# Land Use Department Planning Commission Staff Report

<b>Case No:</b>	2025-11380
<b>Hearing Date:</b>	February 5, 2026
<b>Agent:</b>	JenkinsGavin, Inc.
<b>Applicant:</b>	Titan Development
<b>Request:</b>	Development Plan
<b>Location:</b>	1000, 1101, 1103 Cerrillos Road
<b>Case Mgr.:</b>	Claudia Kath
<b>Zoning:</b>	C-2 (General Commercial)
<b>Overlay:</b>	Zone 1 of the Cerrillos Road Highway Corridor Protection District and Suburban Archaeological District
<b>Pre-app Mtg:</b>	August 14, 2025
<b>ENN Mtg:</b>	September 30, 2025
<b>Proposal:</b>	The Applicant requests approval of a Development Plan to construct a 79,491sq.ft. AC Marriott hotel with 150 rooms on a 3.40-acre parcel.

**Case #2025-11380. 1000, 1101, and 1103 Cerrillos Road Development Plan.** JenkinsGavin, Inc., Agent, for Titan Land Development, on Behalf of Gilliam Land Trust, owner and applicant ("Applicant"), requests approval of a Development Plan, for a 79,491 square foot, four-story, 150-room AC Marriott hotel. The subject properties comprise 3.40 +/- acres and are located within the Suburban Archaeological Review District and Cerrillos Road Highway Corridor (Zone 1) and zoned C-2 (General Commercial) (Claudia Ka

Figure 3 - Traffic Analysis Plan

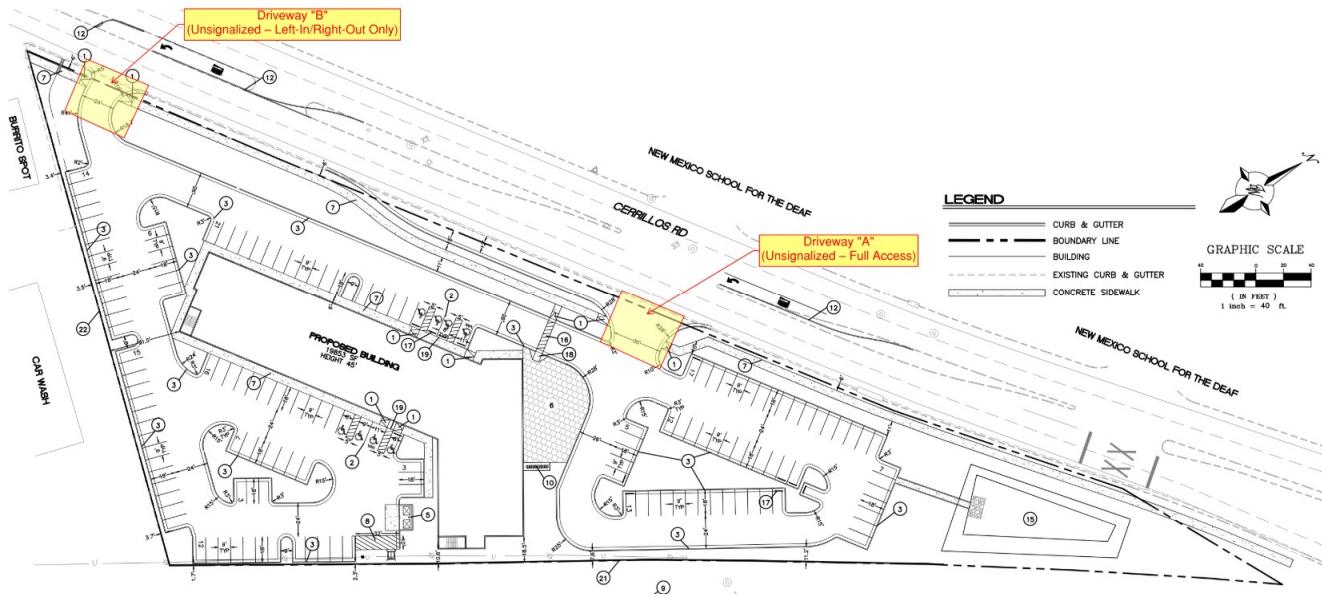
A Traffic Impact Analysis (TIA) prepared by the Applicant is included in Attachment C of this report. The site currently contains nine curb cuts along Cerrillos Road; these will be consolidated into two access driveways serving the hotel. The Development Review Team (DRT) traffic engineer has noted that Driveway "B" (the access point closest to Burrito Spot) must be restricted to right-in/right-out movements in accordance with New Mexico Department of Transportation (NMDOT) comments.

There is no sidewalk abutting the site; as a result, a volunteer path has formed along the very narrow dirt section adjacent to the fence. A 6-foot sidewalk will be constructed which will provide safer pedestrian access.

Figure 4 - Terrain Management Plan

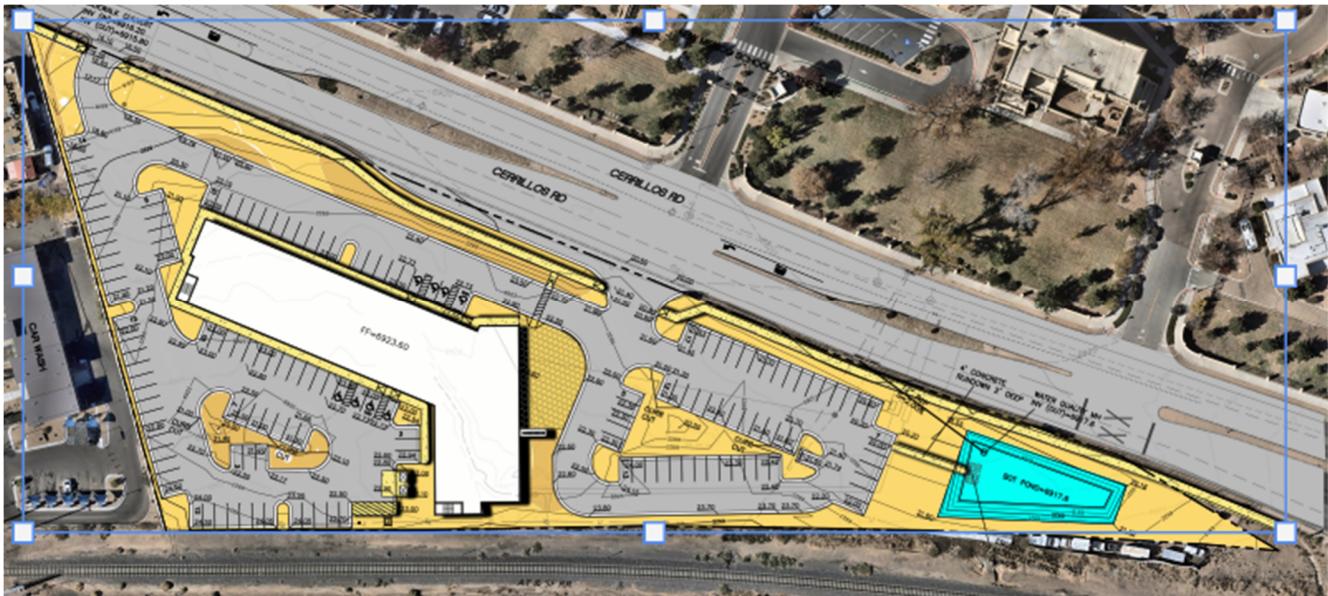
The DRT has required the retention pond incorporate a meandering layout to be planted with raingarden-appropriate vegetation and trees. Along the Cerrillos Road frontage, the project will include a 5-foot-wide planter with street trees and a 6-foot-wide sidewalk.

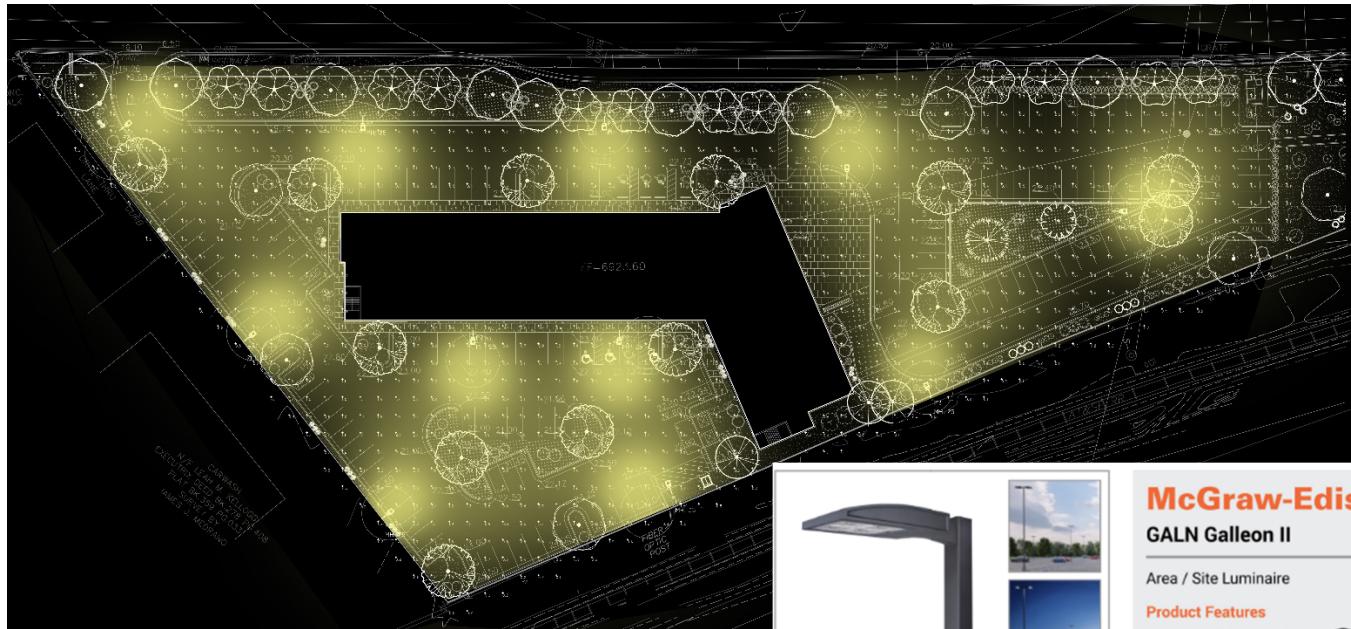
The Lighting plan shown in the diagram below includes only overhead downcast pole-mounted fixtures within the parking area. All exterior fixtures will be required to meet the City's Night Sky Ordinance and the requirements of § 14-8.9 Outdoor Lighting. Staff is adding a condition that the Applicant revise the Lighting plan to show all exterior fixtures and address nuisance glare. This includes ensuring all pole

fixtures and any additional outdoor fixtures include shields on that focus the illumination downward.

*§ 14-8.9(D)(3) General Standards (3) All outdoor luminaires shall be designed, installed, located and maintained such that nuisance glare onto adjacent properties or streets shall be minimized to the greatest extent practicable. Disabling glare onto adjacent properties or streets is not allowed.*

Figure 8 - Building Elevations – North and West

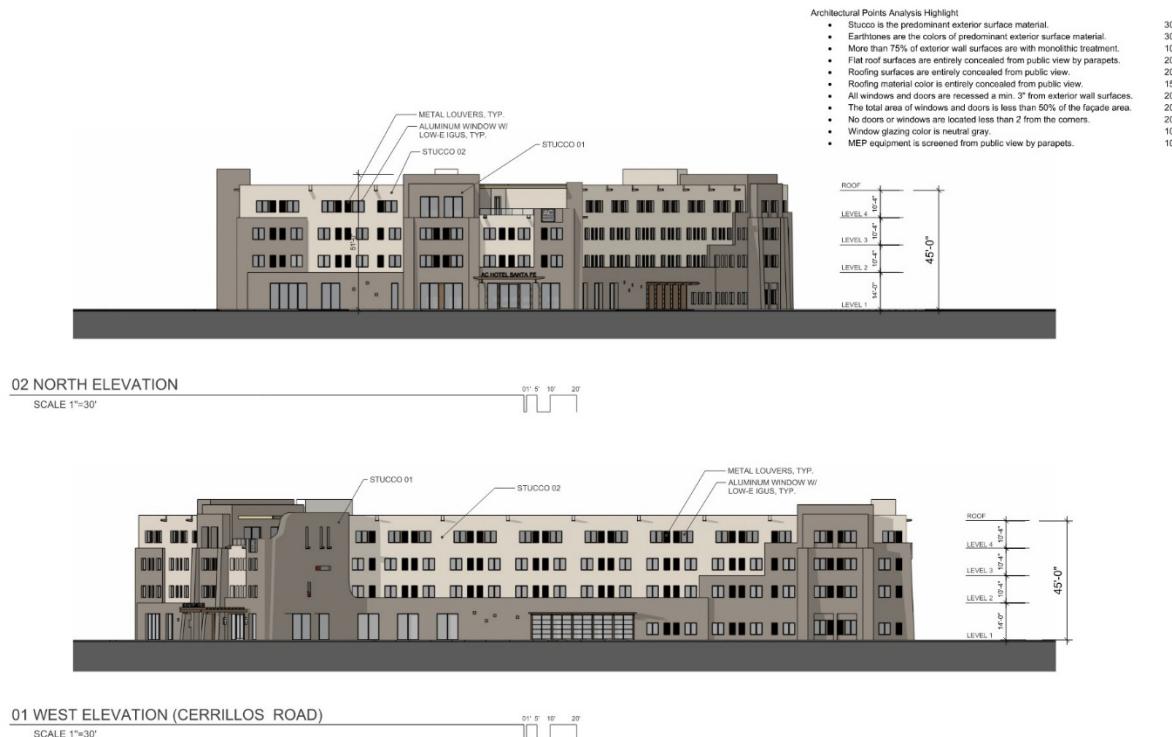
Publicly visible façades incorporate step-backs and wall-plane projections; however, these projections and setbacks do not fully meet the requirement that they have a depth of at least three percent of the façade length while also extending across at least 20 percent of that length. The changes in color along the facade help to provide visual interest in order to break up the building's mass.
